Glenwood MS Envelope Renovation
Addendum Number 1
3/13/2020

To: All Plan Holders
Project: HCPSS Glenwood MS Envelope Renovation
Re: Addendum Number 1

To the Contract Drawings and Specifications for the referenced project as dated below, as prepared by Hord Coplan Macht Architects in conjunction with OAK Contracting LLC, this addendum includes changes and clarifications to the Contract Documents as follows:

Glenwood MS Envelope Renovation
HCM Project No. 219169.00

Drawing
ENLARGED PLAN & ELEVATIONS -
LIBRARY CLERESTORY

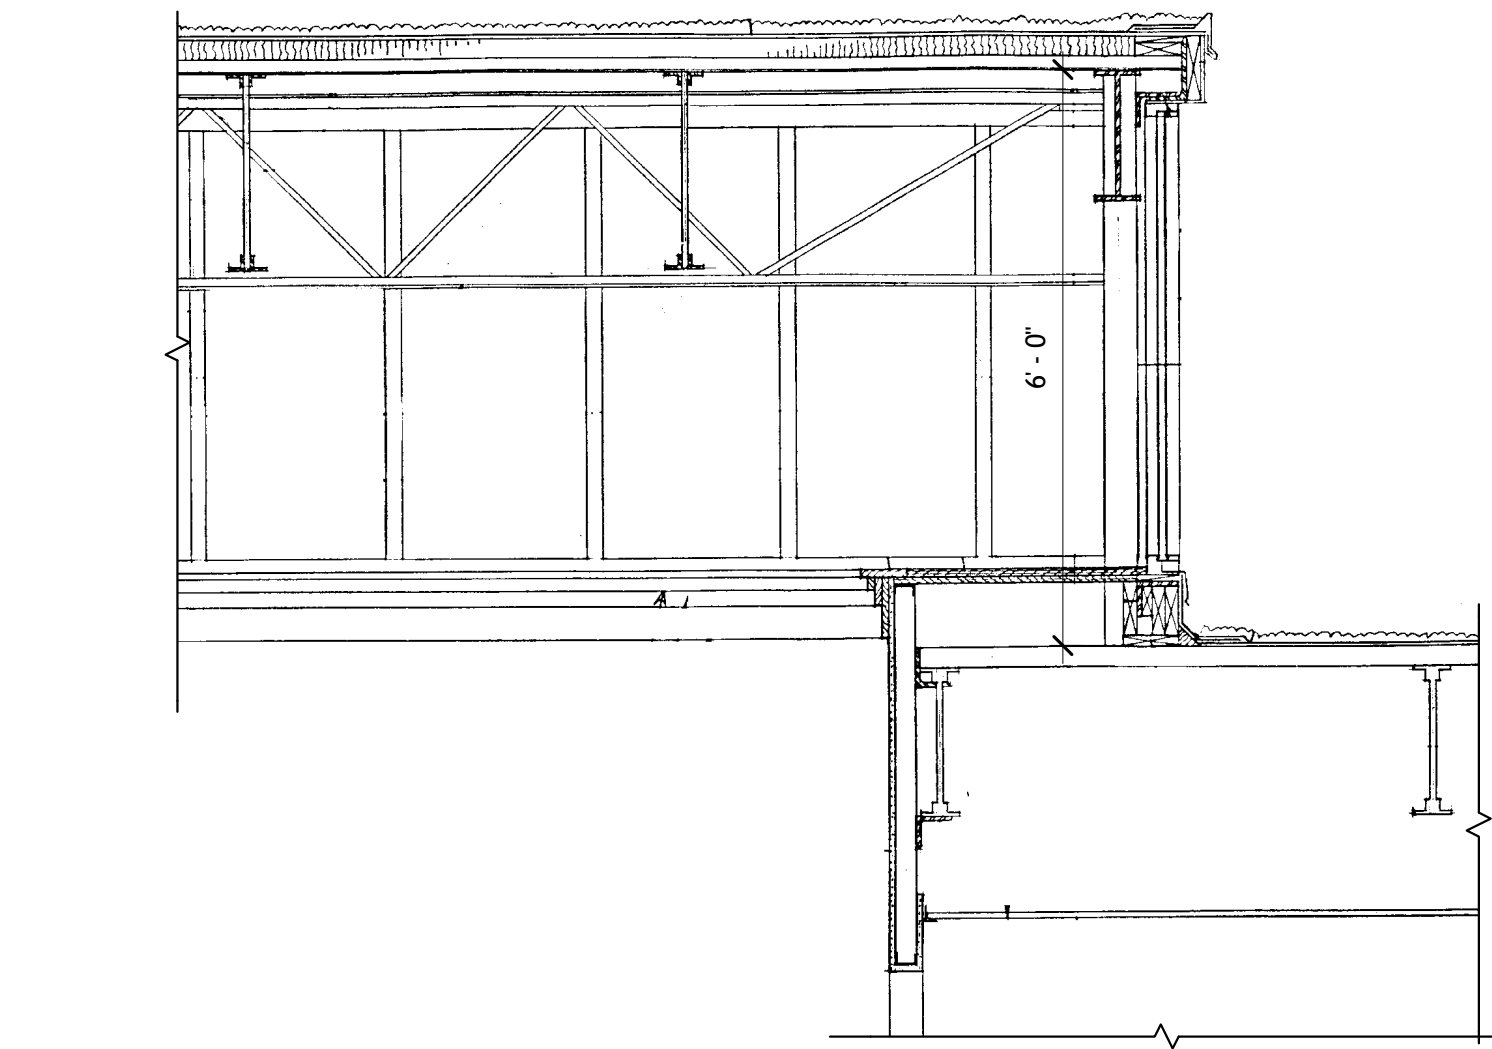
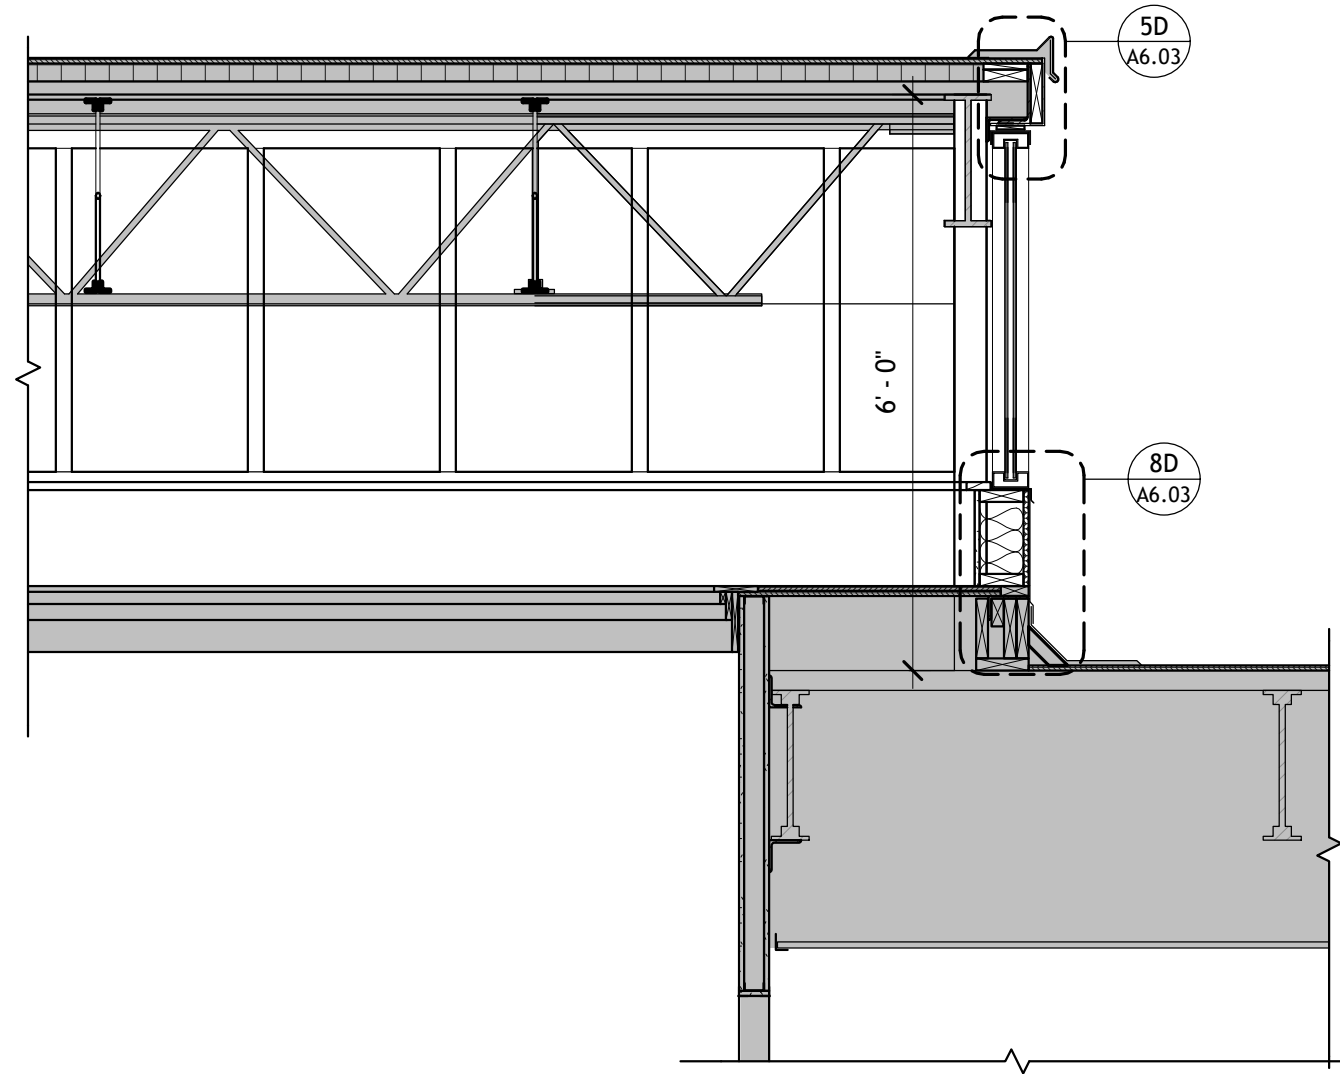
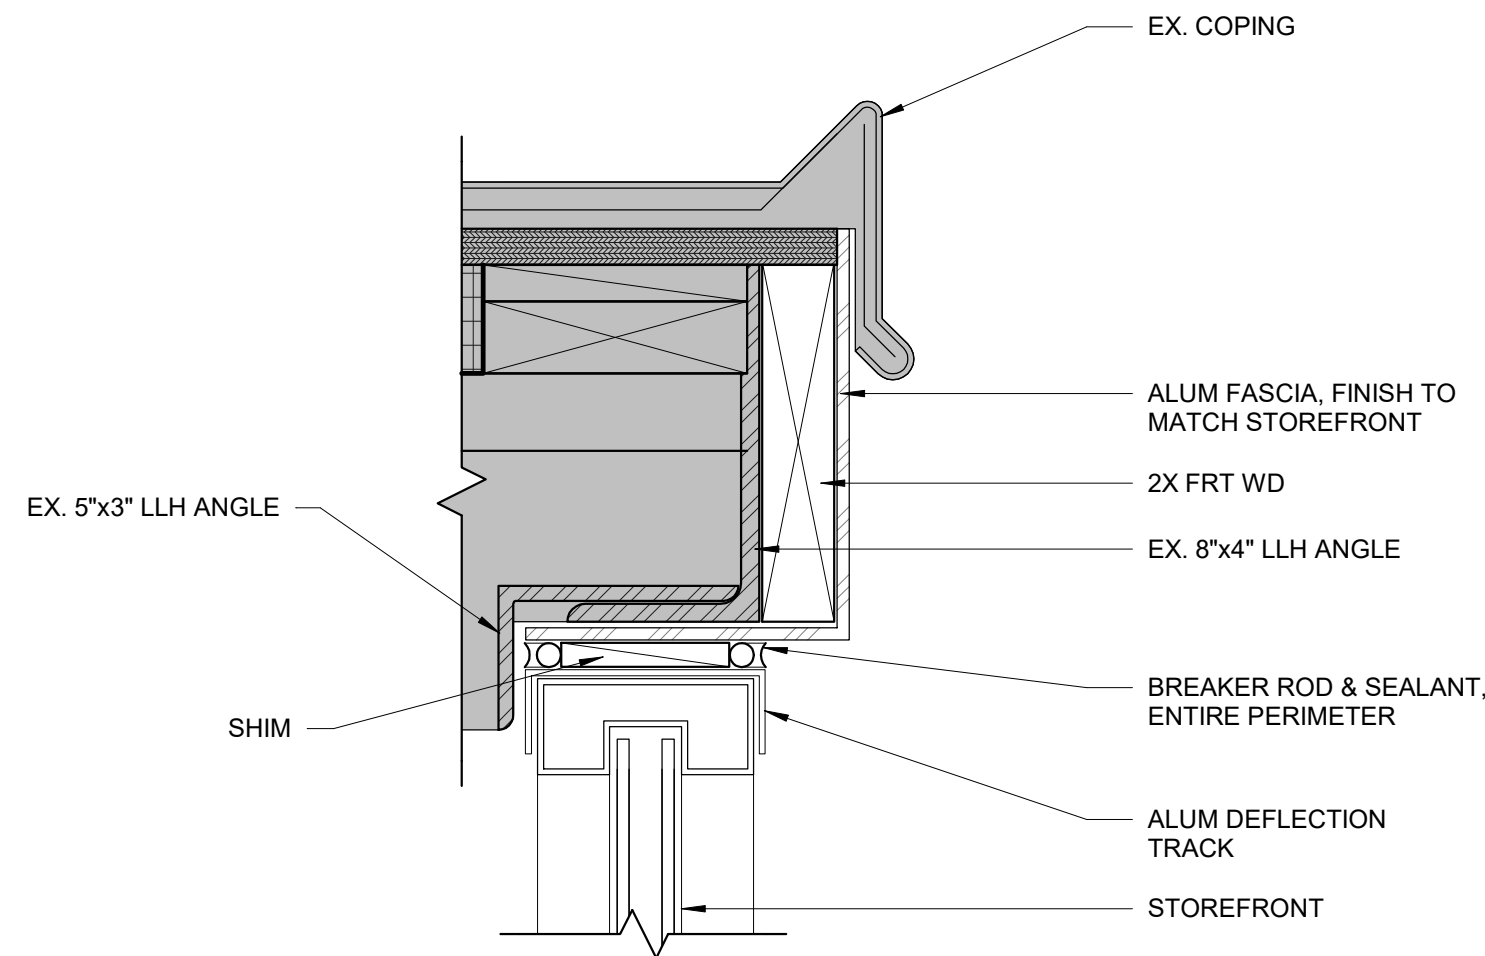
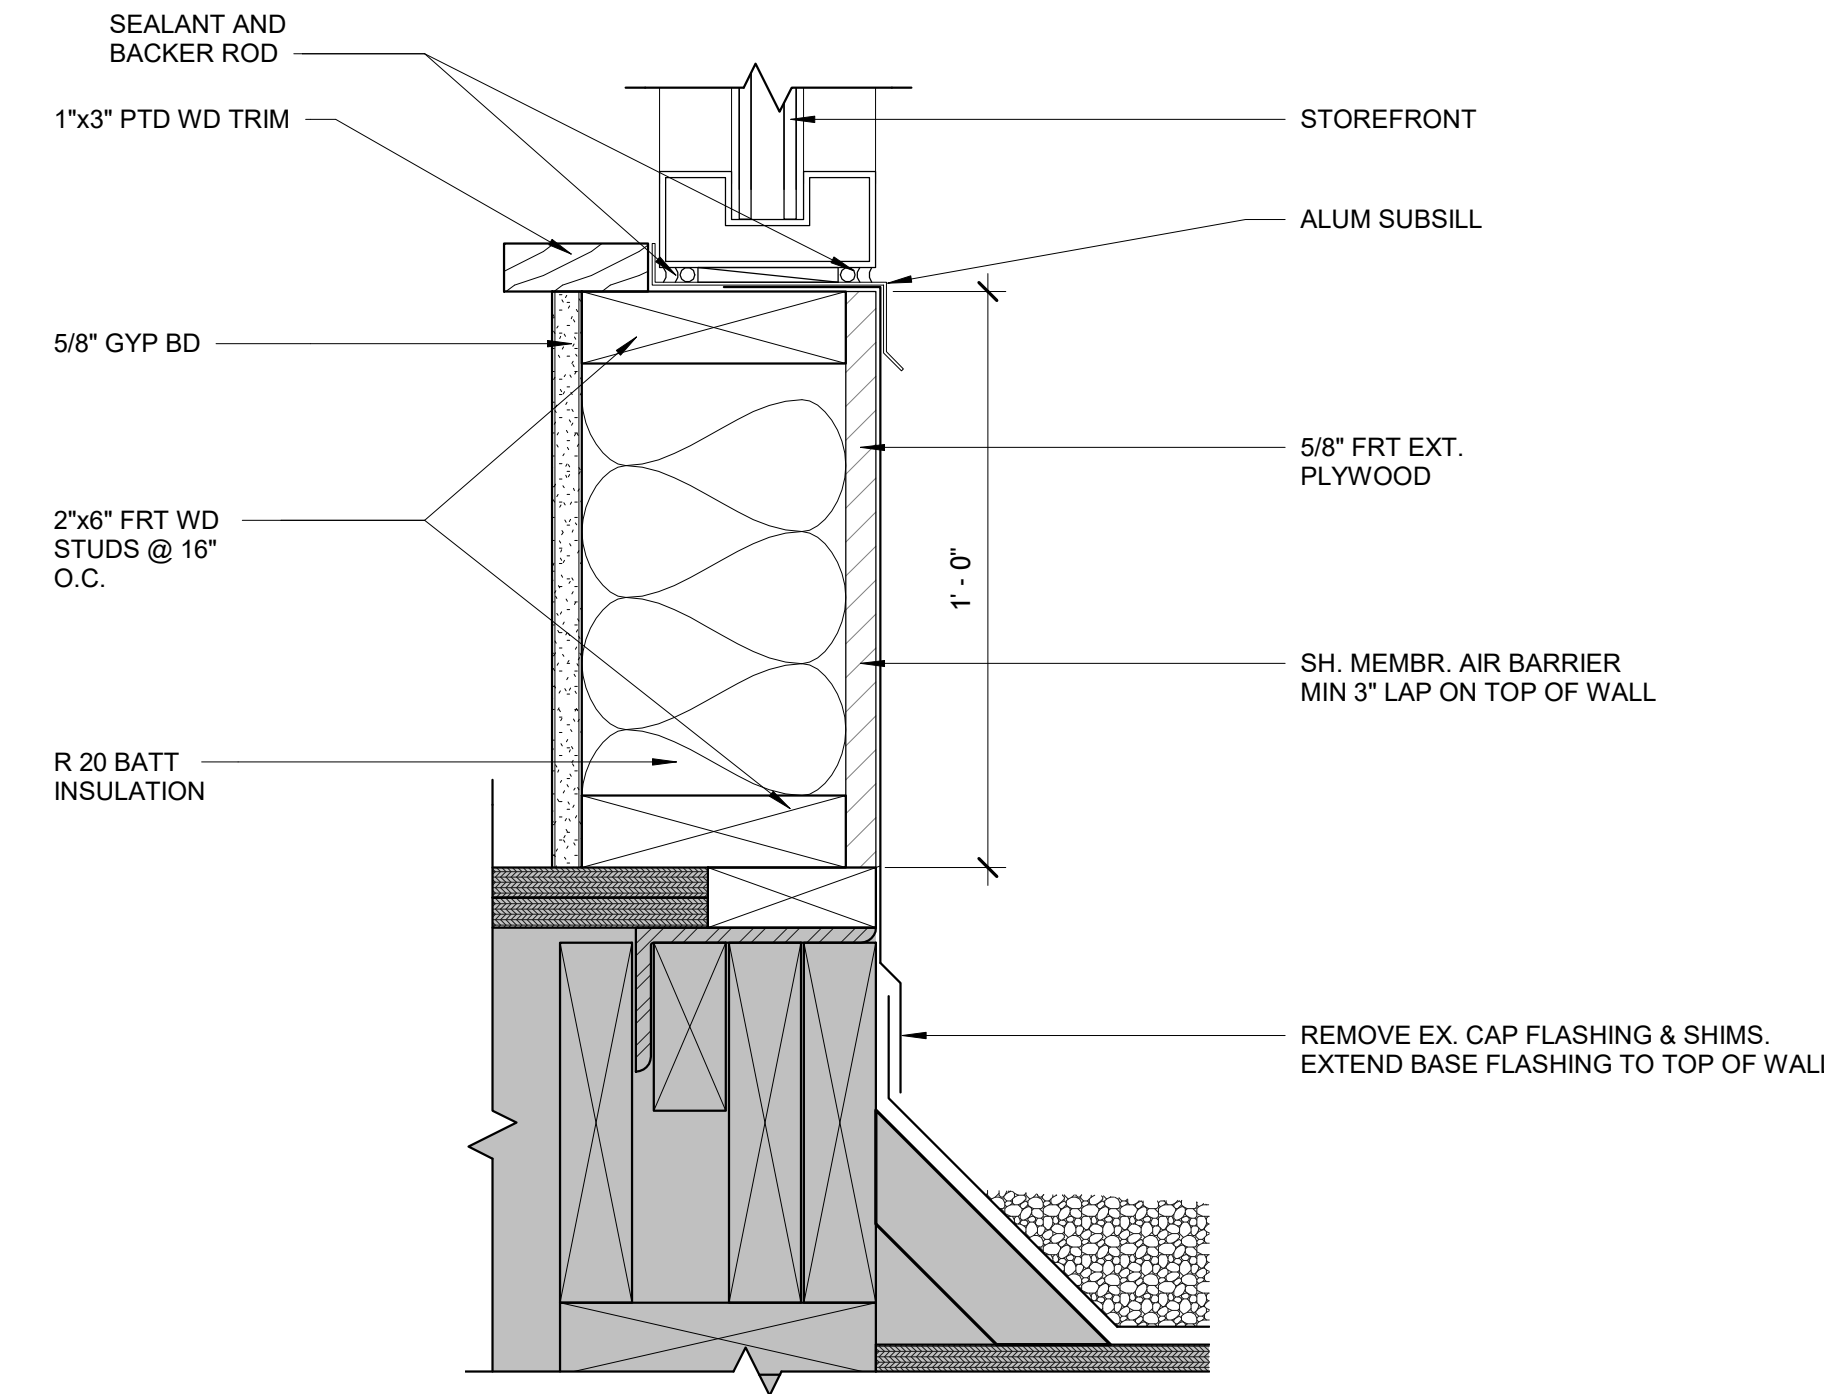
Drawing A6.03 shows an overall height of 6' on the clerestory but no length is provided. Please clarify

Each window panel is approximately 1'-11" center to center. The overall lengths of the clerestory windows are noted on detail 8A/A9.01 of the addendum, but will need to be verified in field.

8H EX. EAST & WEST ELEVATIONS - LIBRARY CLERESTORY
A1.01 A6.03 1/4" = 1'-0"

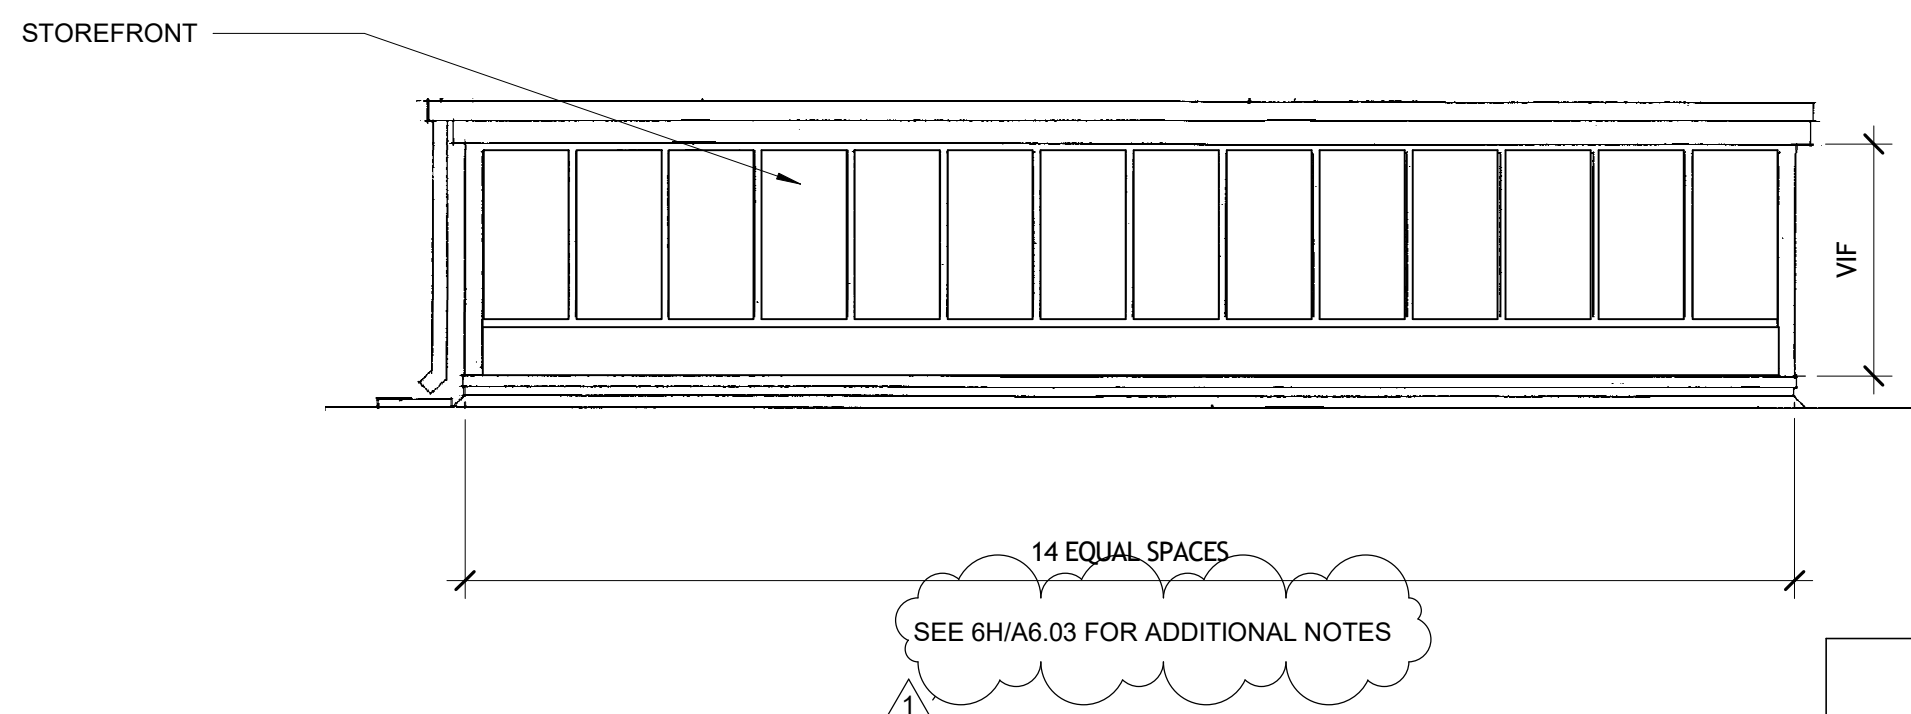
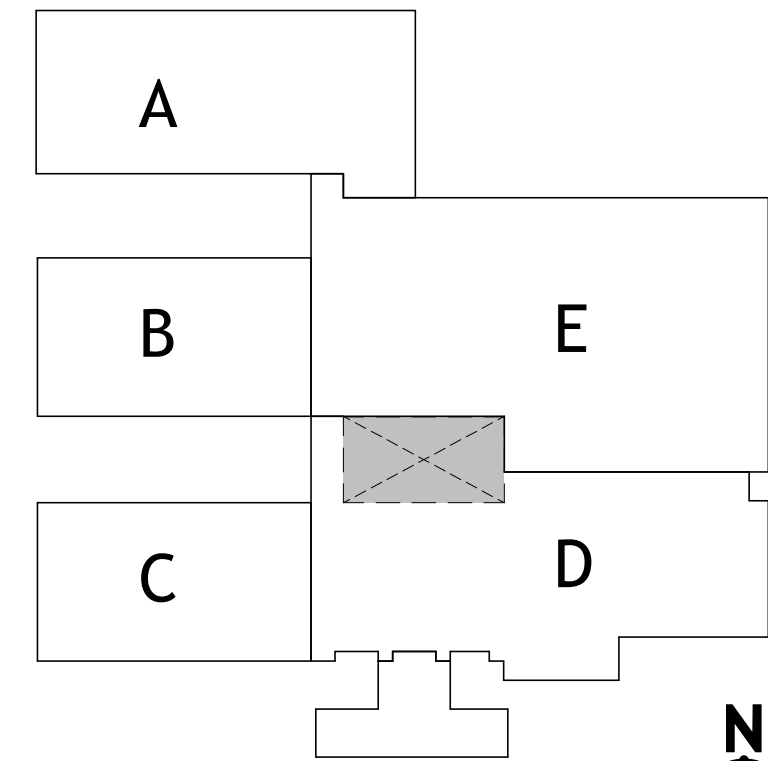
Drawing A6.03/detail 8H includes a note to see 7/A6.03 for additional notes. This detail is not provided. Please provide.

This note has been revised to read "See 6H/A6.03 for additional notes."

4D WALL SECTION - TYP. ENTRY
A2.01 A7.02 3/4\"/>

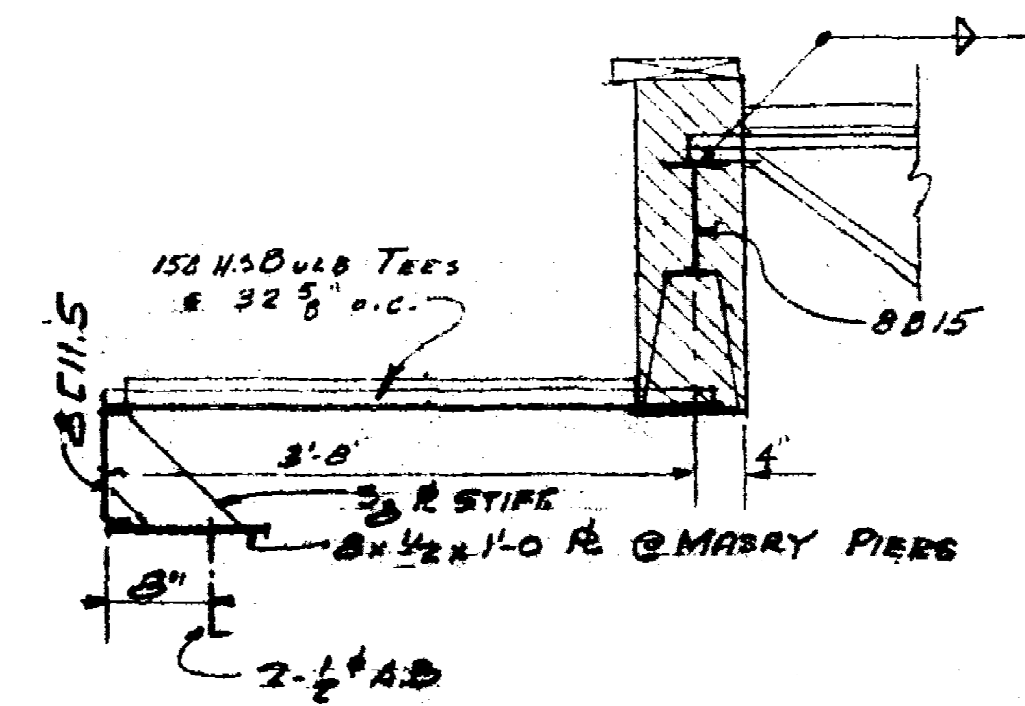
Detail 4D A7.02 calls out 1/4" Clear Wired glass to be glazed at transoms at hollow metal frames. There is nothing in the glazing spec that mentions wired glass. Please clarify if there should be wired glass at transoms.

No wired glass. The transom should be 1" insulated glass as per Door Type F on sheet A9.01.
